Reliability Analysis Update PJM – Mid-Atlantic

Subregional RTEP Committee – PJM MA

Baseline Cost Update – b3134

ODEC Transmission Zone b3134 Cost Update

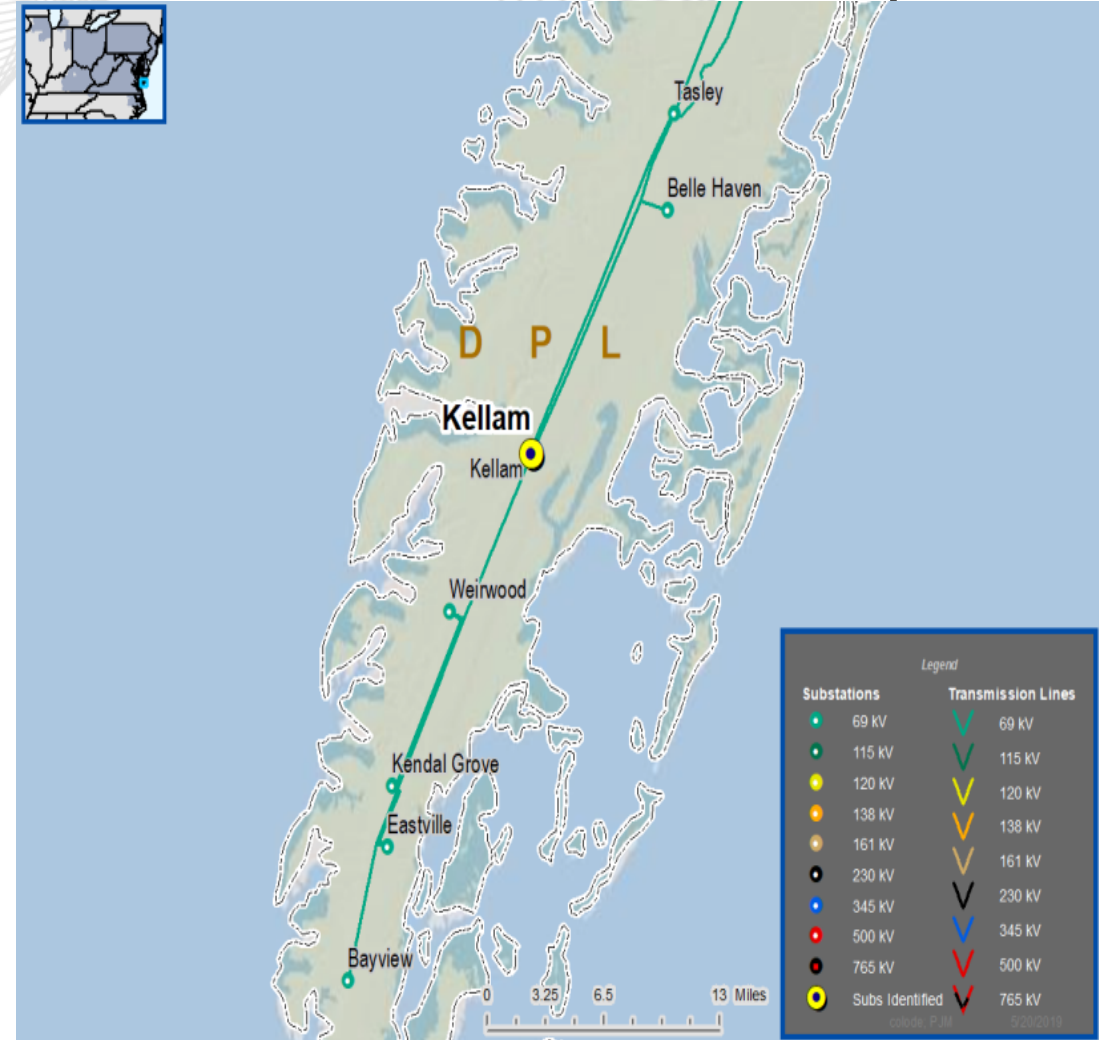
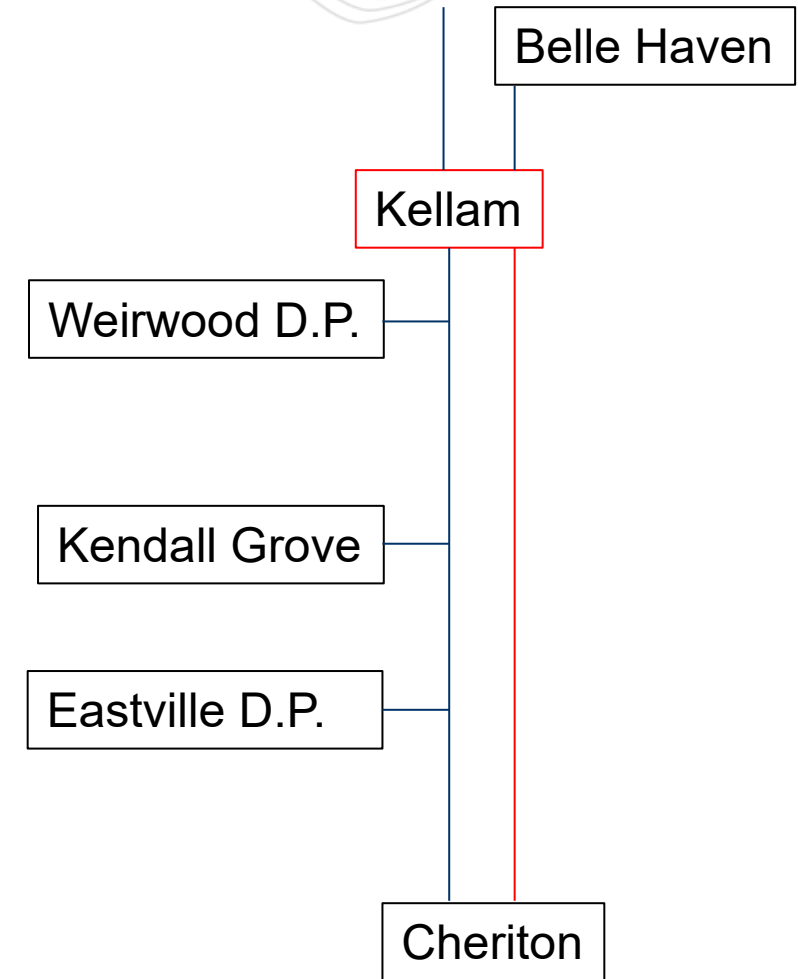
The load south of Kellam Substation violates the MW-Mile criteria. 21 Miles x 37.2 MW = 781.2 MW-Miles

- Reconfigure the Kellam ring station to create a line terminal for the new 69 kV circuit to Cheriton S/S. Cheriton S/S is a new under construction station (ID s2027) with a 2023 in-service date (**b3134.1**)
- Build a new single circuit 69 kV overhead line from Kellam S/S to new Cheriton S/S (21 miles). (**b3134.2**)

Reason For Cost Increase:

Significantly higher material and construction costs as compared to pre-Covid estimates. Further design changes were required to minimize community impact, meet APLIC guidelines and stay within the existing ROW easements; taller, more robust, un-guyed monopole structures with deeper foundations were required. As well as substation scope expansion including line re-termination and protection and control upgrades.

Old Estimated Cost: \$22M

New Estimated Cost: \$43.4M

Projected In-Service Date: 12/31/2027
